Intel® High Definition Audio Specification

Document Change Notification

Change Identification: **DCN No: HDA015-B**
Document Revision: Intel® High Definition Audio 1.0

Title: Low Power Capabilities Clarifications and Enhancements

Figure F1. Power State Field Definition

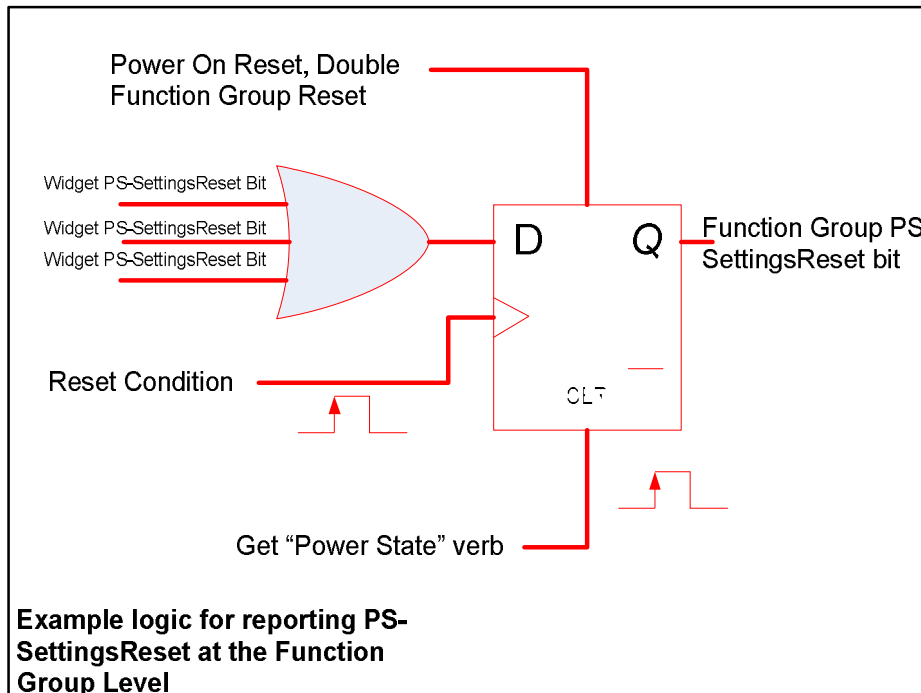
The PS-SettingsReset bit for individual widgets, will be cleared to zero (0) on receipt of any “Set” verb to that widget; or After responding to a get Power State verb, to that widget, with the response containing PS-SettingsReset set to one (1).

The PS-SettingsReset bit for the Function Group is handled differently than at the widget level. For the Function Group the PS-SettingsReset is set to one (1) when any widget sets its PS-SettingsReset to one (1). The Function Group PS-SettingsReset bit is thus the logical “or” of all the EPSS bits, but is latched so that it can be reset independently and not require that all EPSS bits be reset.

The PS-SettingsReset bit is 'sticky'. Once set, it will retain its value until it's cleared by a 'Get' verb, regardless of other single or double Function Group resets, Dx state transitions etc that may occur in the meantime.

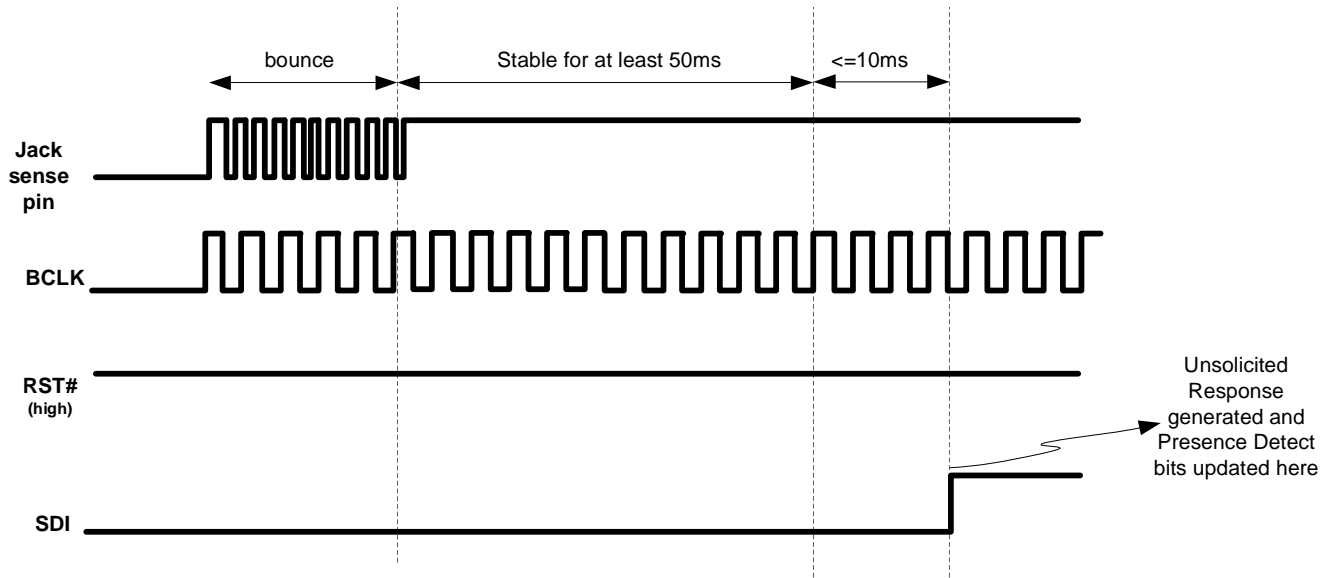
[following text added at the end of existing paragraph 7.4.2]

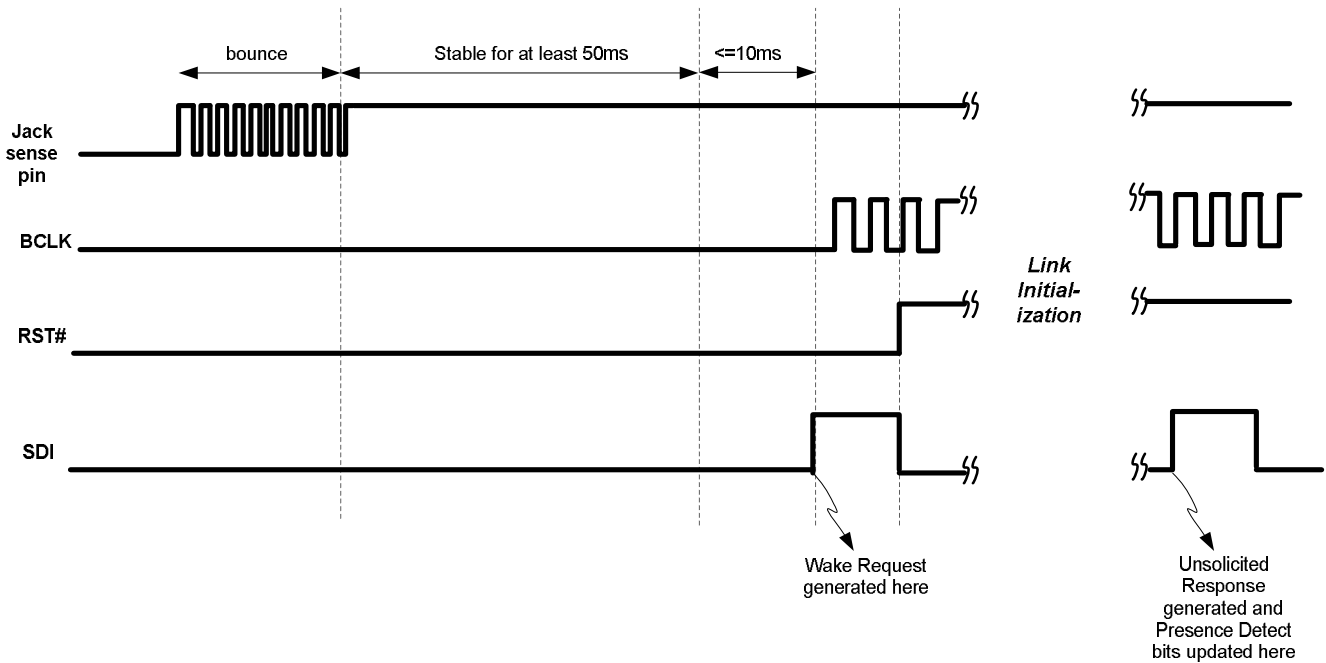
When detecting the insertion or removal of a jack, where the impedance of a shared sense line is being used, the codec shall measure the impedance of the jack's presence detect precision resistors continuously to determine when to report a change of state. Reporting of state change and change in the presence detect state bits shall not occur until any impedance (does not preclude other measurement techniques) change has initially stabilized for at least 50 Milliseconds. From the point at which the impedance has stabilized the codec shall report an Unsolicited Response, if enabled and the High Definition Audio Link clock is running, within 10 Milliseconds. If this clock is not running, then the request to wake the Link shall occur within 10 Milliseconds. Thus any presence detection logic used to detect which resistors are switched in for the purposes of Presence Detection, must operate more quickly than 10 Milliseconds. Once the unplug or plug event has been signaled to the host through the unsolicited response, another event or change of the presence detection bits shall not be generated unless the opposite jack state has been sensed (detected) continuously for at least 50 Milliseconds. The state of the Presence Detect bits for all the jacks associated with a shared sense line shall not change until the point where an Unsolicited Response could be generated, if disabled,

or is generated when enabled. Thus the state of the Presence Detection bits should be “de-bounced” with hysteresis of at least 50 Milliseconds, but longer times are permissible as long as the initial state change and reporting time is met. When the codec has returned to D0 from any lower power state, the state of the presence detection bits must be correct. If the codec power has been removed and the state of the presence detection bits has been reset, the codec shall report this by setting the PS-SettingsReset bit for the affected Pin Widget(s). The timing specifications described above are demonstrated in the following diagrams:

Link clock is running

Link clock is NOT running
